DART AEROSPACE LTD	Work Order: 7A791
Description: Crosstube Assembly	Part Number: D407-667-145
Inspection Dwg: D407-667-145 Rev: C	Page 1 of 1

DRAWING NO. D407-667-145	TITLE CROSSTUBE ASS'Y (407 HIGH FWD)	REV. C	DART AEROSPACE LTD ENGINEERING ORDER		D.E.O. NO. D407-667-145-C-1	SHEET NO. SHEET 1 OF 1	SCALE NTS
DRAWN 97	CHECKED ASS	MFG. APPR. 18	APPROVED WD		DE APPR. ##		
DATE 11.07.15	DATE 11.07.22	DATE 11.07.22	DATE 11/07/22		DATE 11.07.21

PURPOSE:

REPLACE MAGNOBOND WITH PROSEAL.

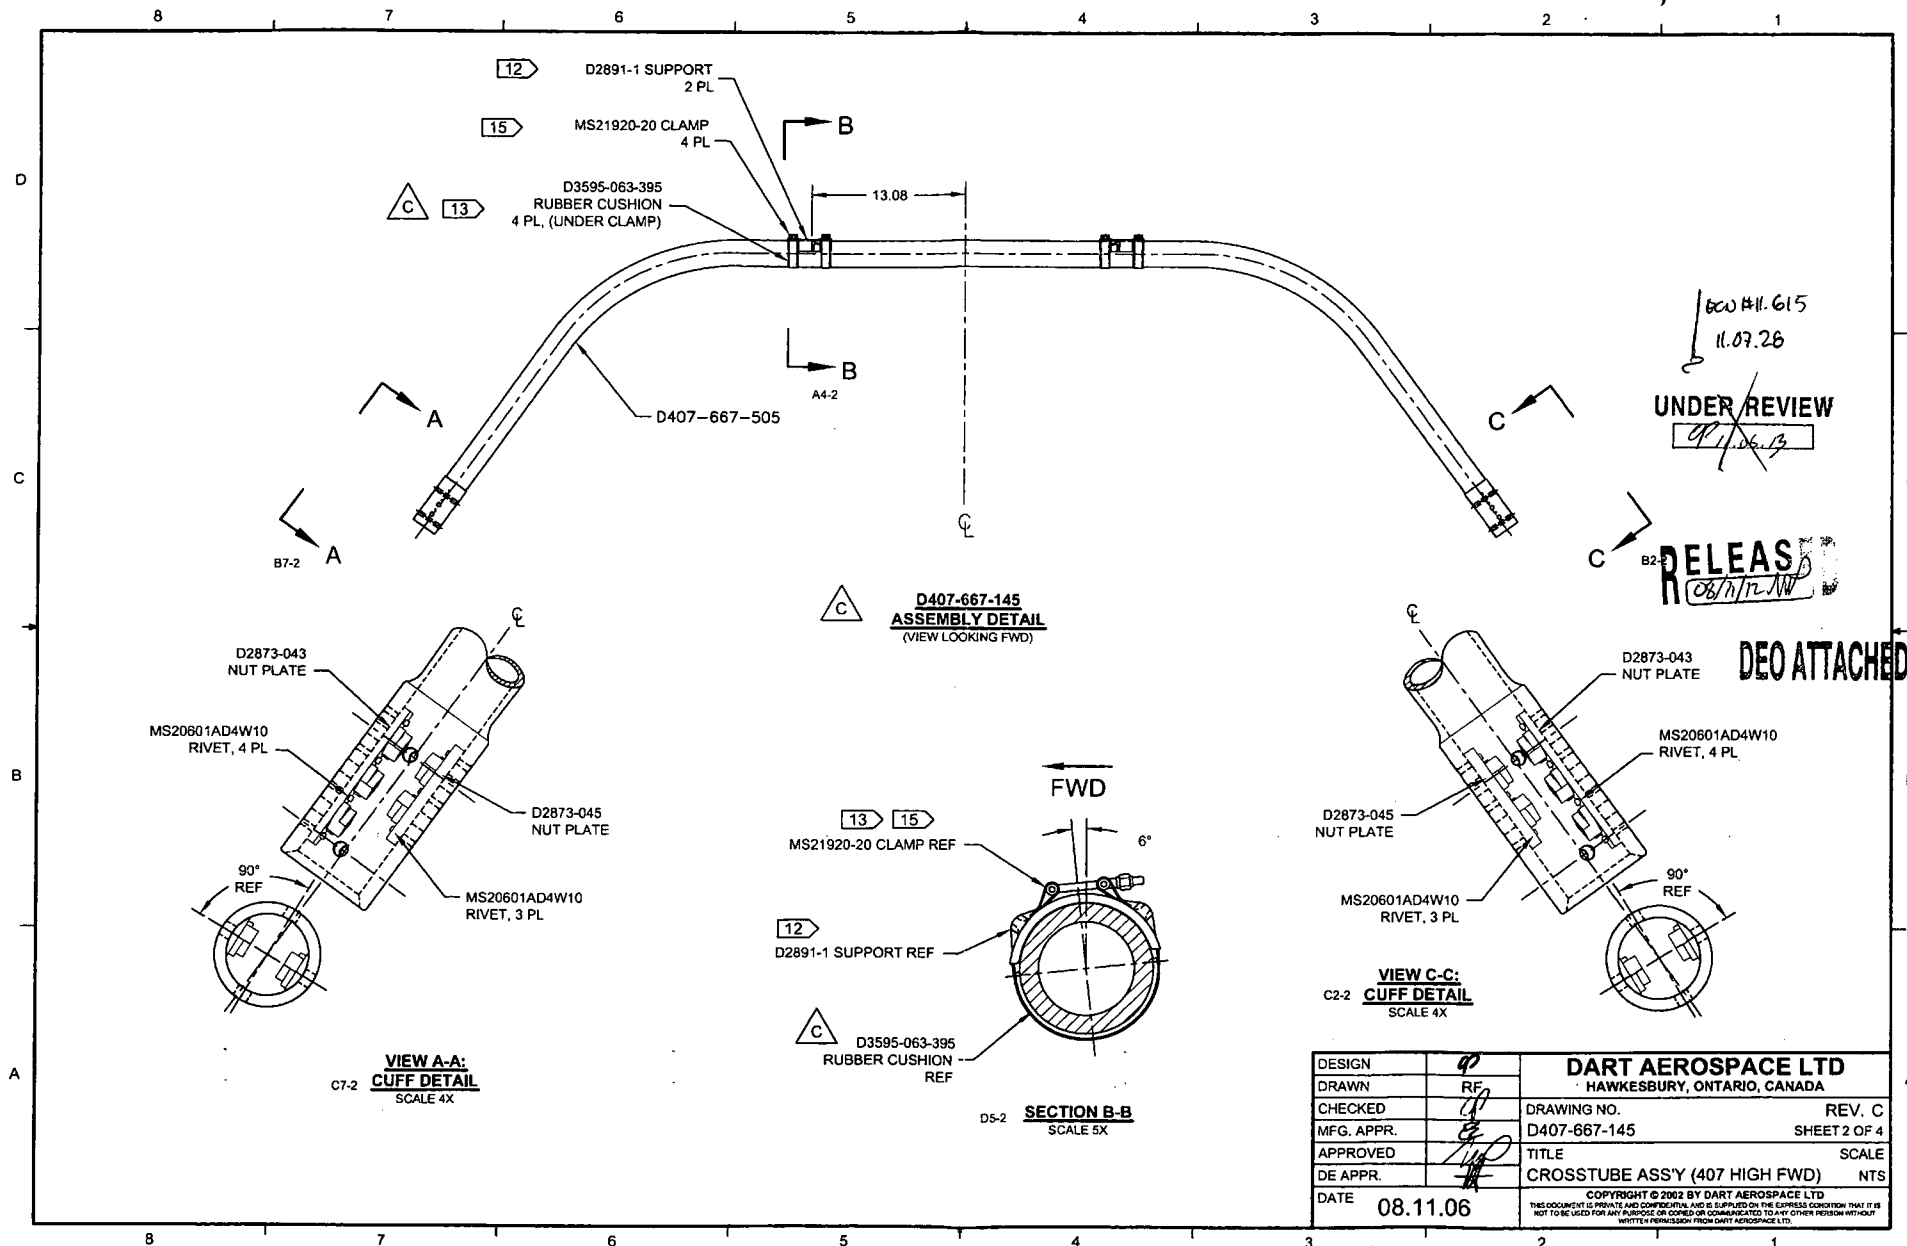
NOTE 12 & 15, SHEET 1 IS AMENDED AS FOLLOWS:

IS:

- 12) TO INSTALL D2891-1 SUPPORT: ABRABE MATING SURFACE OF SUPPORT AND CROSSTUBE WITH 180-GRIT SANDPAPER AND REMOVE RESIDUE WITH MEK (OR EQUIVALENT). APPLY A 0.04" TO 0.07" THICK LAYER OF PROSEAL 890 CLASS B-2 (OR AMS-S-8802 CLASS B-2) SEALANT TO MATING SURFACE OF SUPPORT.
- 15) TORQUE CLAMPS 80 TO 100 IN-LB. ENSURE AT LEAST 1.5 THREADS SHOWING IN SAFETY AND THAT NUT HAS NOT BOTTOMED-OUT AFTER TORQUING. **PRIOR TO PACKAGING, RE-CHECK TORQUE ON CLAMPS AFTER PROSEAL 890 SEALANT HAS CURED FOR 72 HOURS.**

TURNING DETAIL

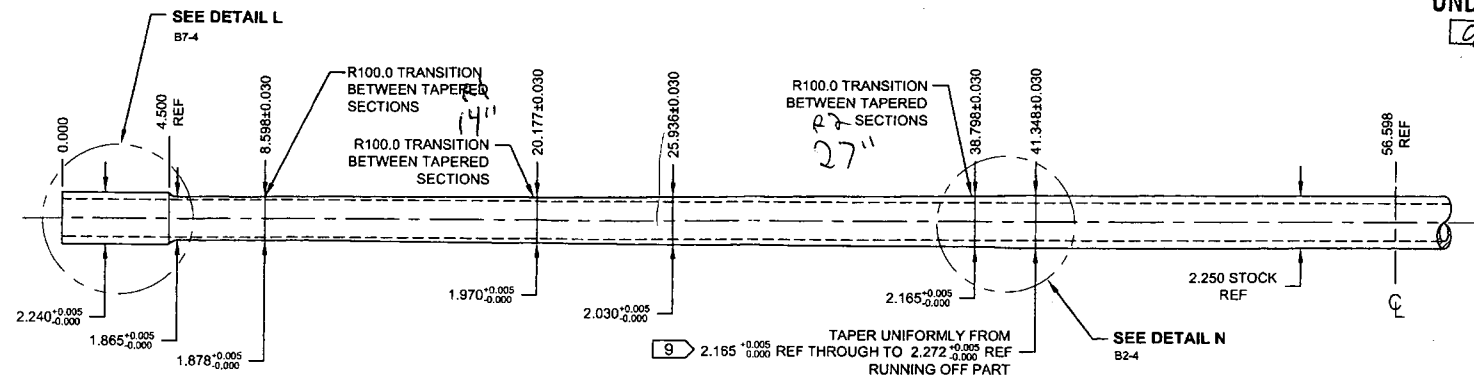
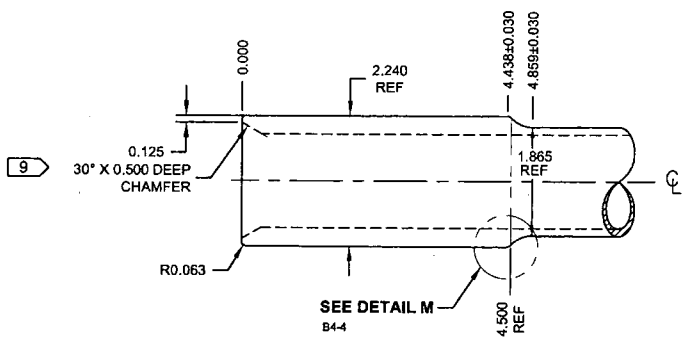
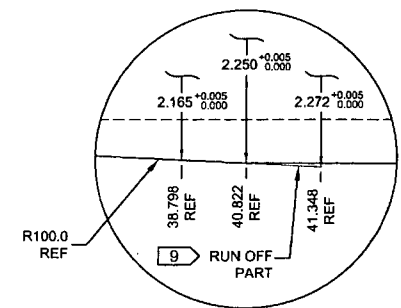
C	REVISE GENERAL NOTES/PART LIST (ZN D7-1); REORGANIZED VIEWS AND REFORMATTED DRAWING TO CURRENT STANDARDS. D3595-063-395 WAS D2856-400-694 (ZN D6-2 & A5-2); REMOVED REF. 7 ADD TOLERANCES (ZN C6-3, C4-3, D2-3); RELOCATED FLAG #6 (ZN A6-3) PER NCR 210; MOVED TURNING DETAIL & UPDATED TOLERANCE TO SHEET 4.	RF	08.11.06
B	ADD HOLES AND NUT PLATES FOR COMPATABILITY WITH BHT/AA SKUDTUBES	PH	05.07.26
A	NEW ISSUE	CP	02.05.08
REV.	DESCRIPTION	BY	DATE
DESIGN	RF	DART AEROSPACE LTD HAWKESBURY, ONTARIO, CANADA	
DRAWN	RF	DRAWING NO.	REV. C
CHECKED	RF	D407-667-145	SHEET 1 OF 4
MFG. APPR.	RF	TITLE	SCALE
APPROVED	RF	CROSSTUBE ASSY (407 HIGH FWD)	NTS
DE APPR.	RF	COPYRIGHT © 2002 BY DART AEROSPACE LTD THIS DOCUMENT IS PRIVATE AND CONFIDENTIAL AND IS SUPPLIED ON THE EXPRESS CONDITION THAT IT IS NOT TO BE USED FOR ANY PURPOSE OR COMMUNICATED TO ANY OTHER PERSON WITHOUT WRITTEN PERMISSION FROM DART AEROSPACE LTD.	
DATE	08.11.06
